TRAFFIC ENGINEERING STAFF REPORT FOR THE TRAFFIC AND PARKING COMMISSION

APPEAL # 1

Appeal new driveway access onto Murfreesboro Pike west of Martway Drive and east of Edge-O-Lake Drive.

APPEAL # 2

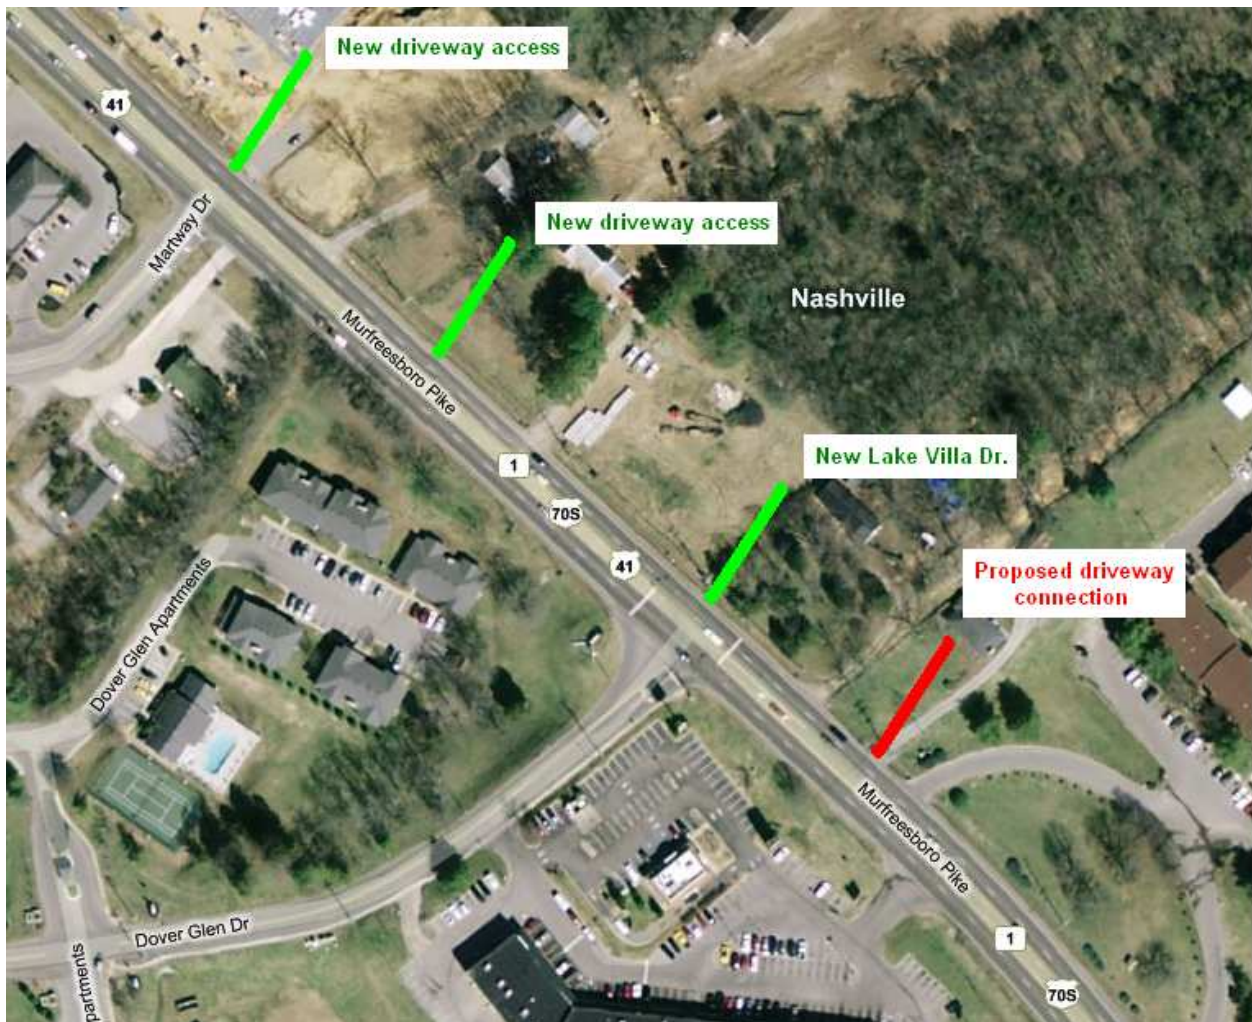
Appeal new driveway access onto Murfreesboro Pike east of Dover Glen Drive from a proposed convenience store with fuel pumps.

The Edge-O-Lake/Dover Glen mixed use development is requesting a driveway connection from the proposed development site on the north east side of Murfreesboro Pike. This site will have two access points onto Lake Villa Drive. The overall development will have approved access points from the new Lake Villa Drive, a new driveway opposite of Martway Drive, a new driveway between Martway Drive and Lake Villa Drive, and from Edge-O-Lake Drive. The proposed development will consist of retail and residential components.

The proposed driveway that has been denied would be located approximately 170 ft from the intersection of Murfreesboro Road and Lake Villa Drive. The driveway would be located at the beginning of the WB right turn lane taper, and generates safety and operational concerns. If the driveway is moved outside of the taper, it will be less than 100 ft from the intersection. In addition, the driveway does not meet the minimum required separation from an intersection on an arterial.

Deny appeal
